North Rainier Landbanked Park Development
Seattle Design Commission March 5, 2020

11.21.19 Design Commission Comments on Preferred Alternative

Site Use Diagram: Family Picnic

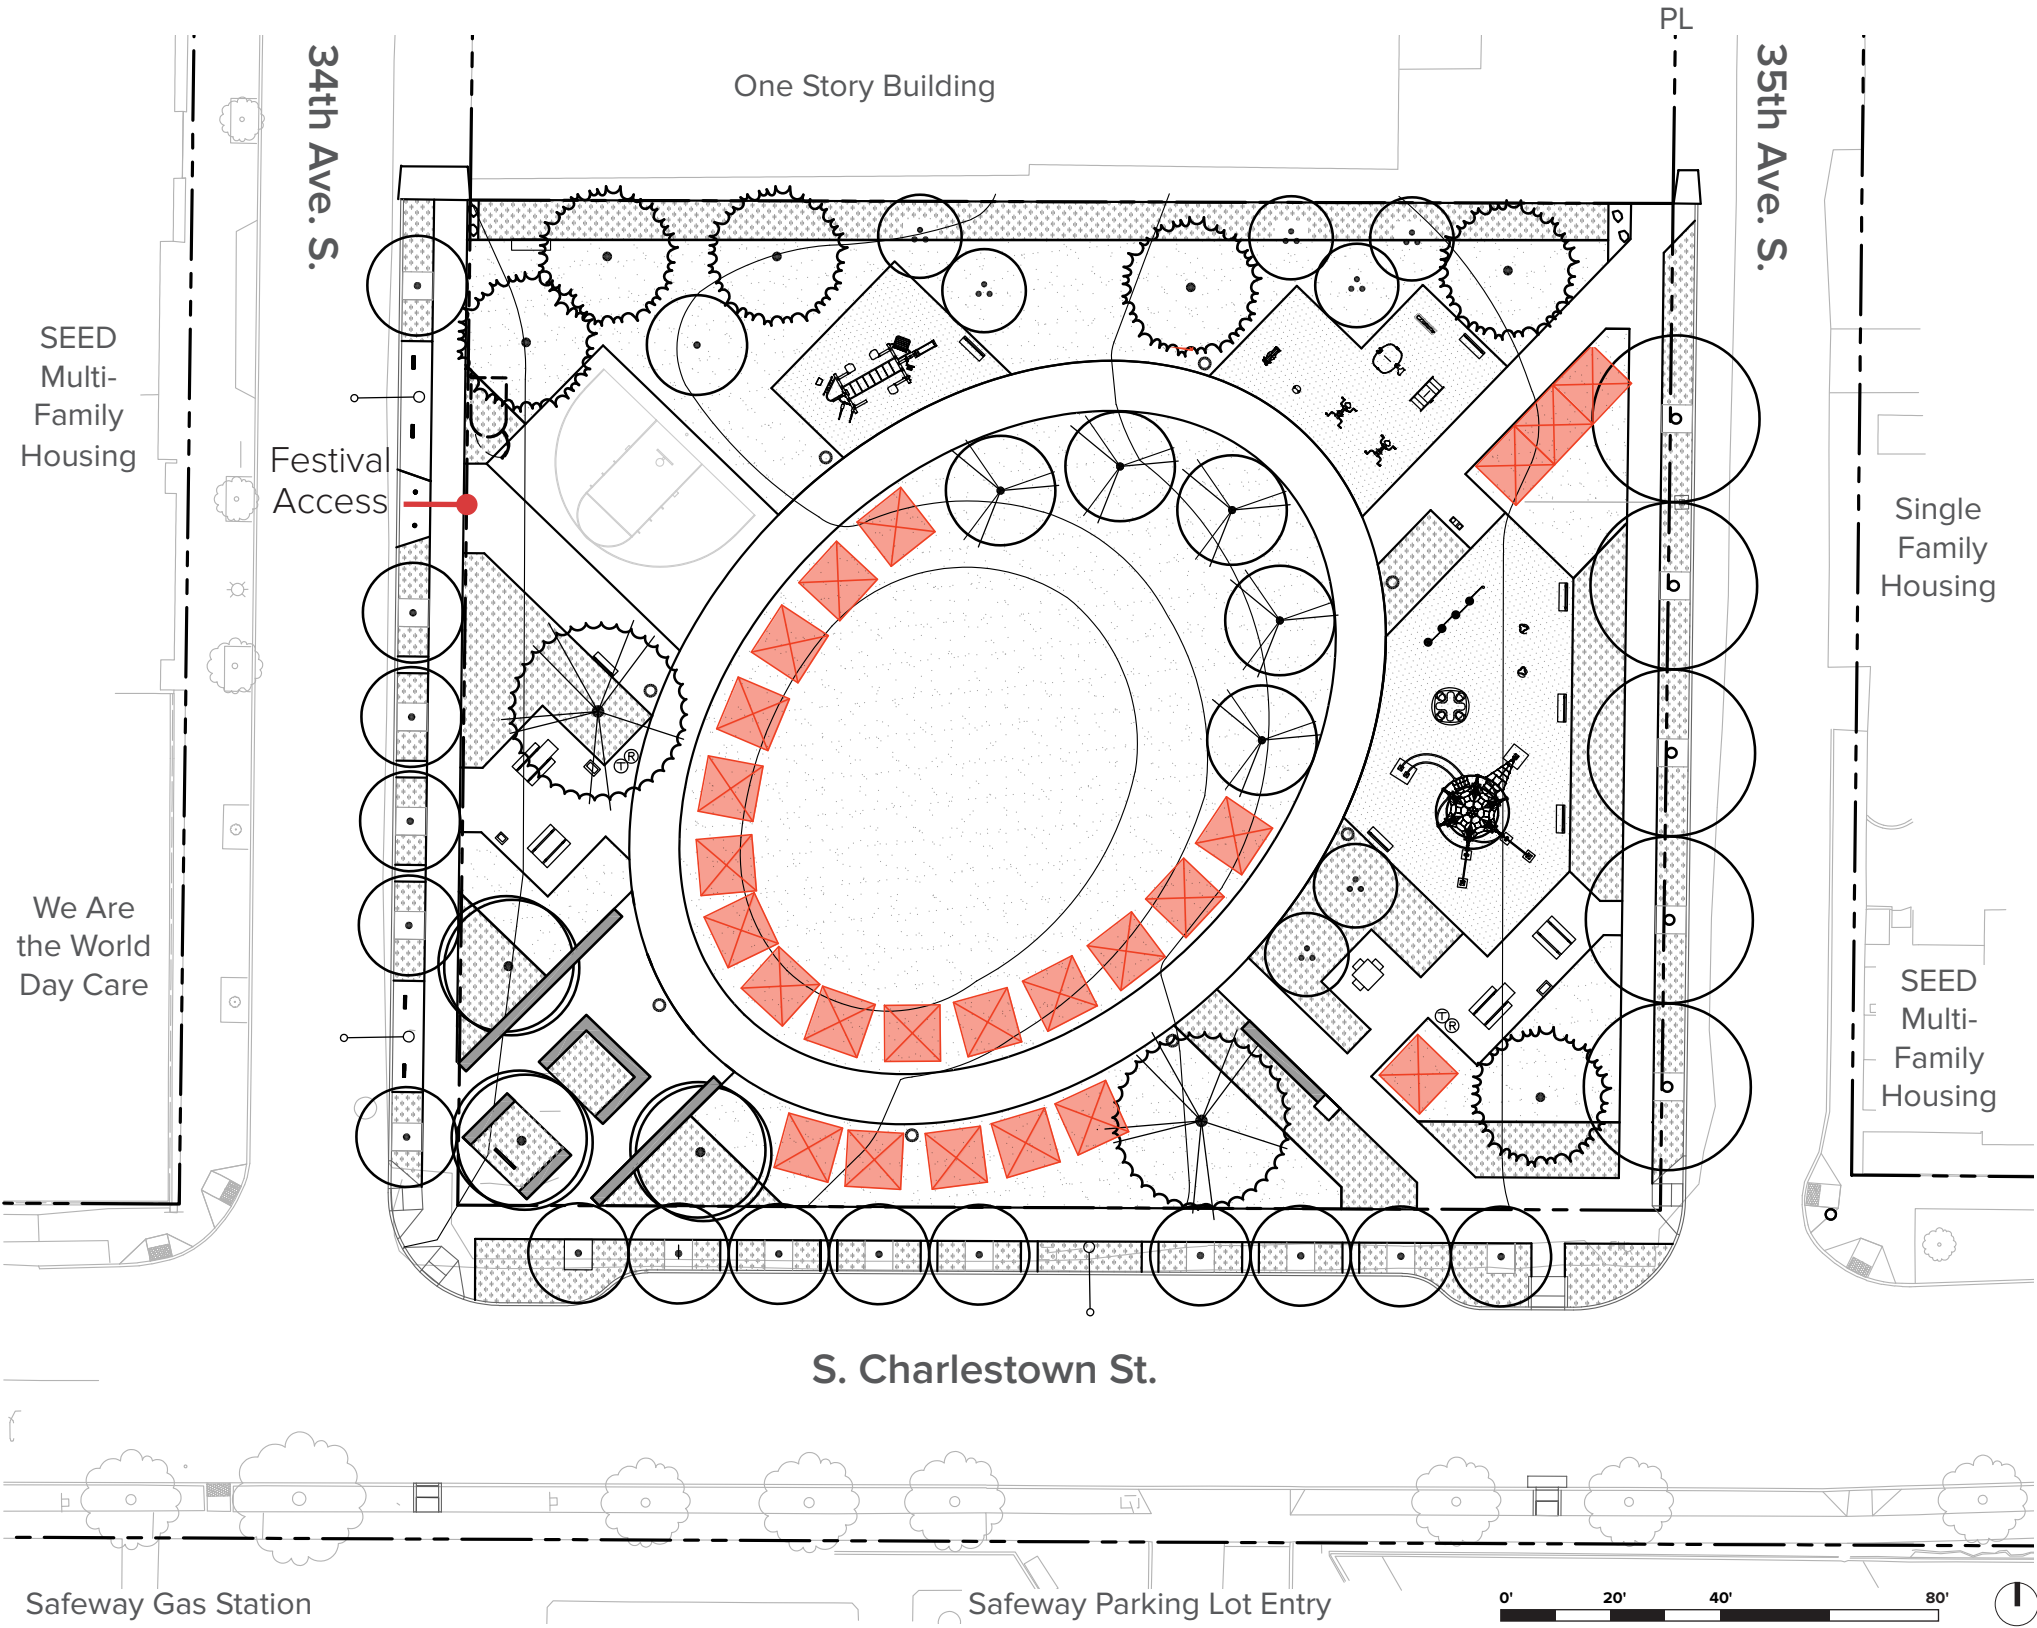
SDC Comments:

A Family Gathering

Family picnics and barbecues are a high priority for the neighboring residents as many of the nearby apartment complexes do not allow barbecues.

A variety of options are available for family picnics, including permanent facilities and adjacent lawn areas for additional canopies or activities.

Plan of Northern Edge

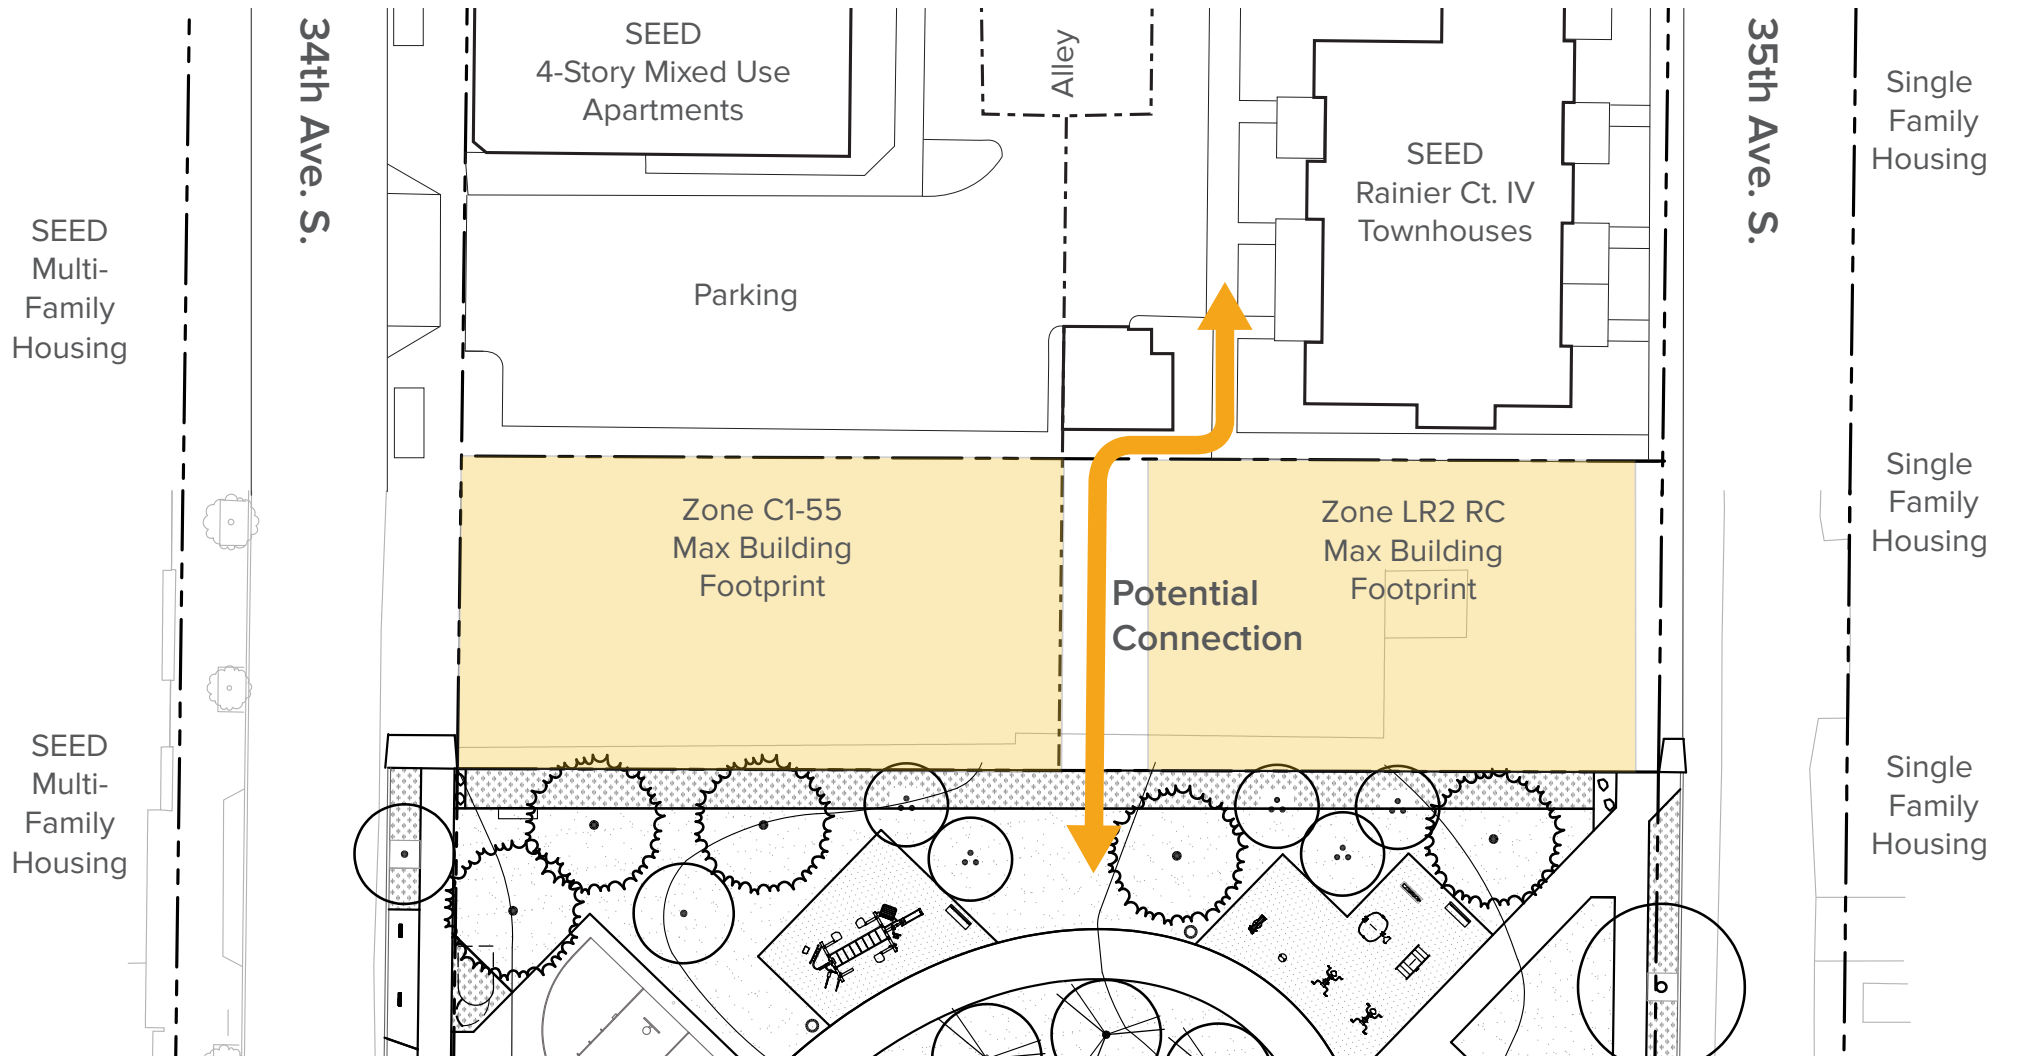
SDC Comments:

B Northern Edge

The northern edge of the park is designed to accommodate a potential future development on the lot north of the park. Further north than this is the SEED housing development.

The lot to the north is currently for sale. SEED and Parks are in discussion about possible collaboration to develop the parcel as additional SEED housing and park space.

The northern edge of the park is opened up in the middle in anticipation of a 8' wide pedestrian path coming from the north and aligned with the central alley of the SEED development. The area is unprogrammed to remain flexible to accommodate future needs.

The planting along the northern park will be mid to low understory planting with a combination of deciduous and evergreen trees, limbed up to allow sight lines for safety.

Materials Palette

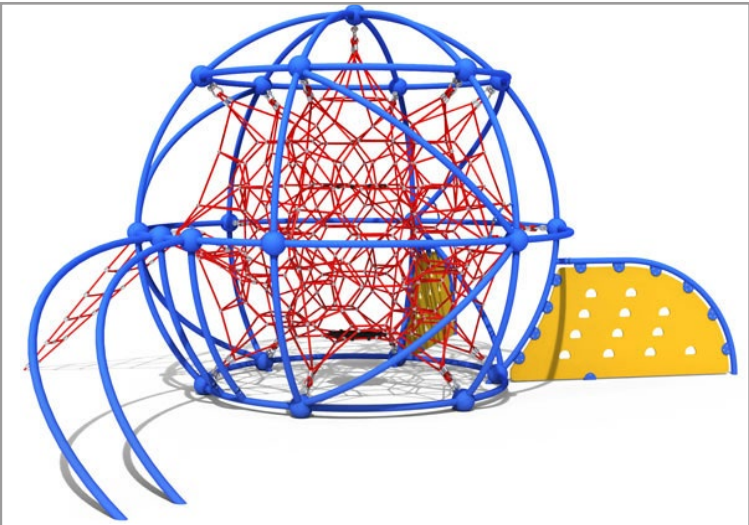
SDC Comments:

H Sustainability for Site Furnishings

Play equipment and surfacing is durable and made of recycled and recyclable materials.

Materials Palette

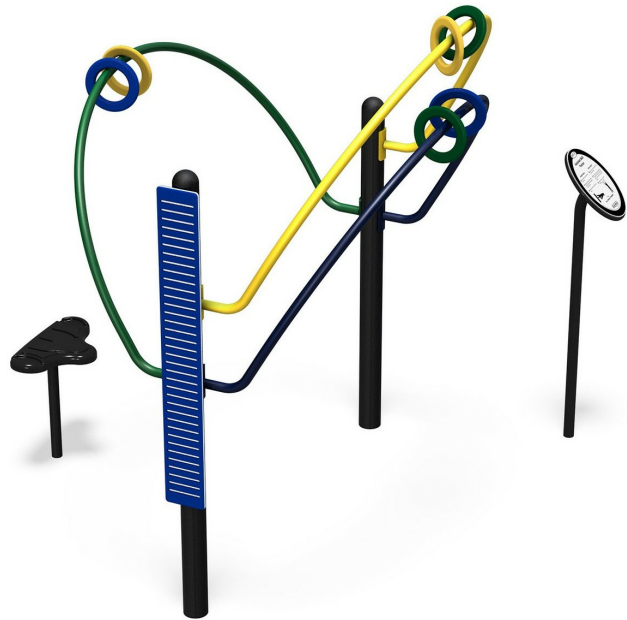
SDC Comments:

H Sustainability for Site Furnishings

Cultural Expression and Inclusion

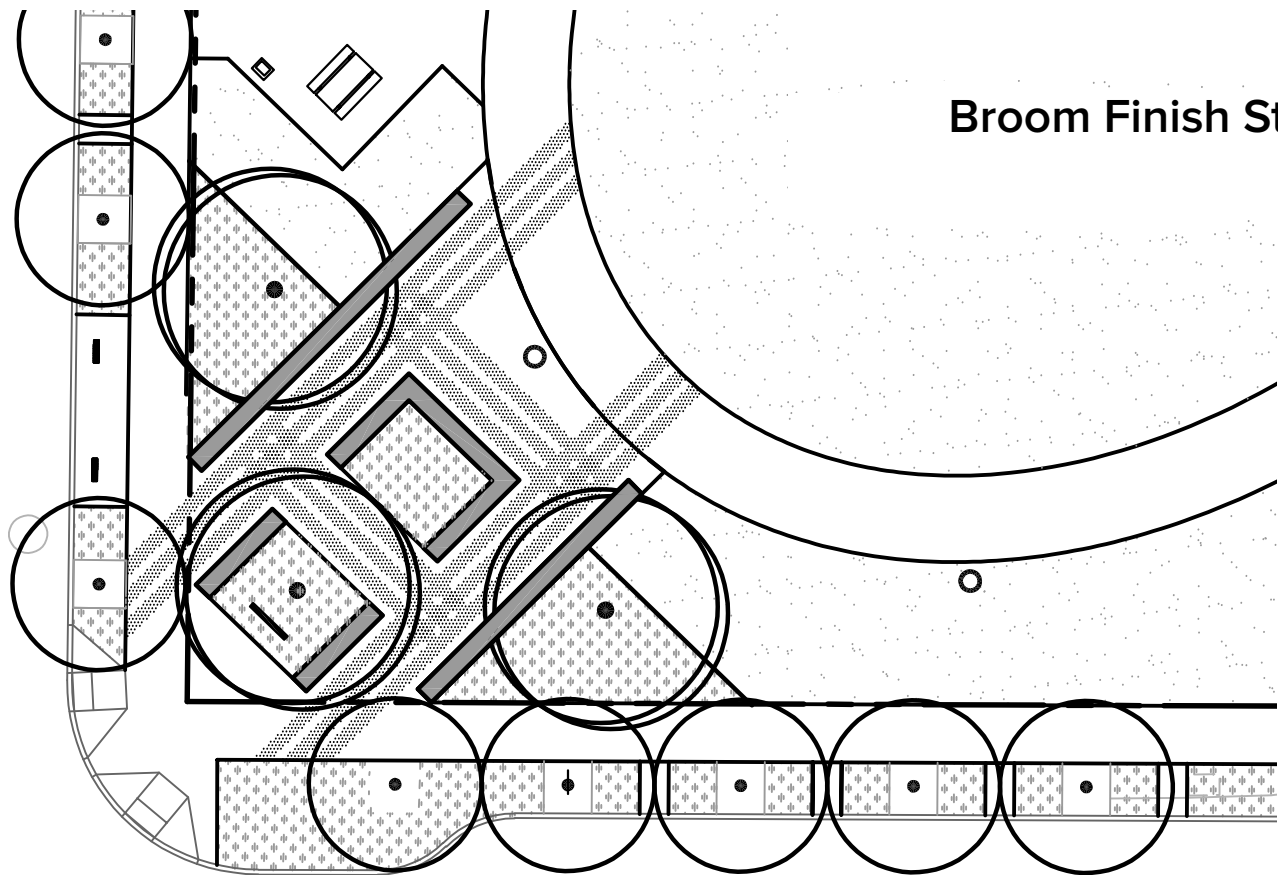
SDC Comments:

- D** Integration of Art + Culture
- F** Cultural Elements in ROW

Cultural inclusion in the park requires working with the neighboring community to generate relevant expression of their cultures. Meetings will take place in Spring 2020 to test ideas presented here and to determine the final form of cultural inclusion.

Proposed media include 8 banners mounted on the pedestrian pole lights which surround the central lawn, and pavement patterning at each entrance to the park.

The banners are a cost effect media, which can be changed through time as desired to continue to represent this evolving neighborhood.

Cultural Expression

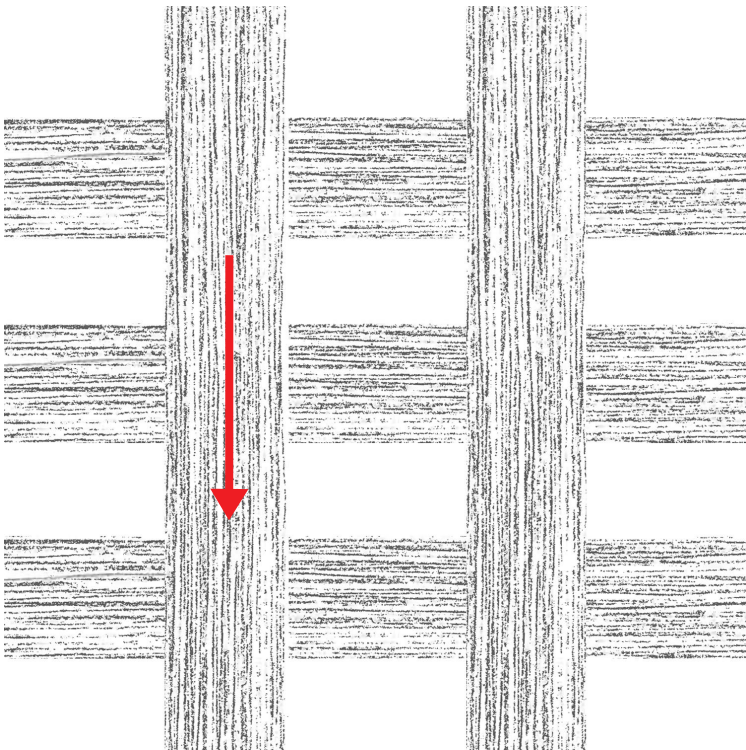
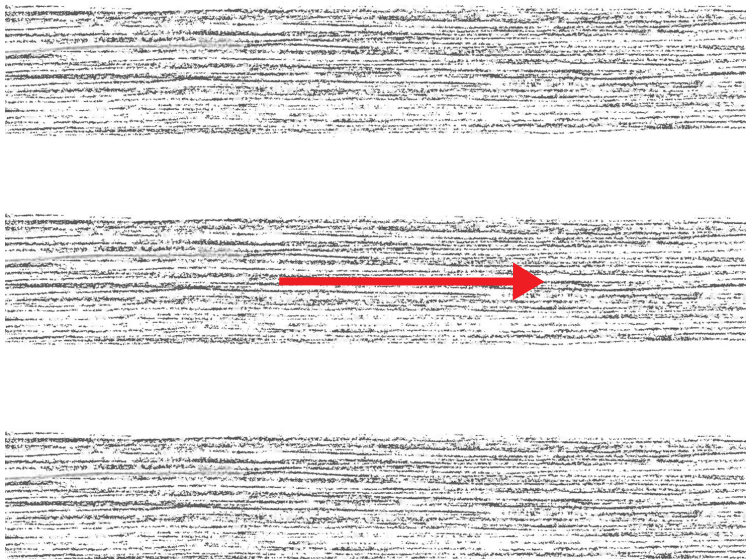
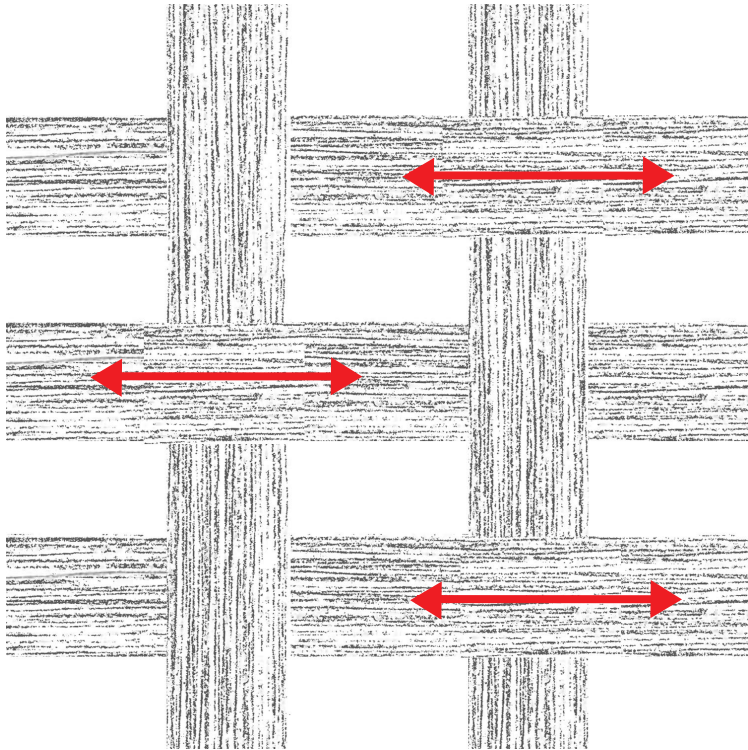
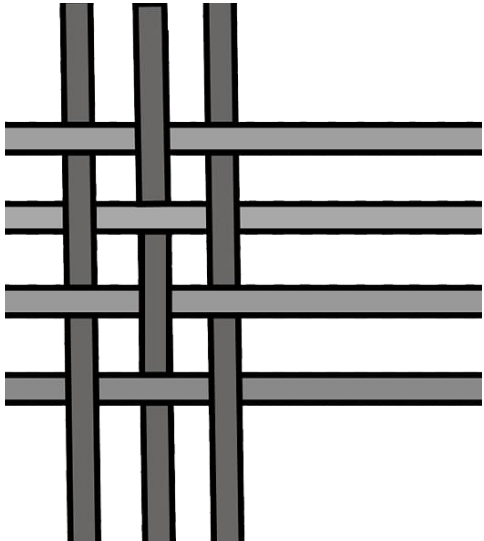
- SDC Comments:**
- D** Integration of Art + Culture
 - F** Cultural Elements in ROW

The theme of weaving or fabric can be expressed at the entries with specialty pavement.

A deep broom finish integrated into the pavement between the seat walls at the main entry invites street-side pedestrians into the park, and extends through to intercept the loop trail.
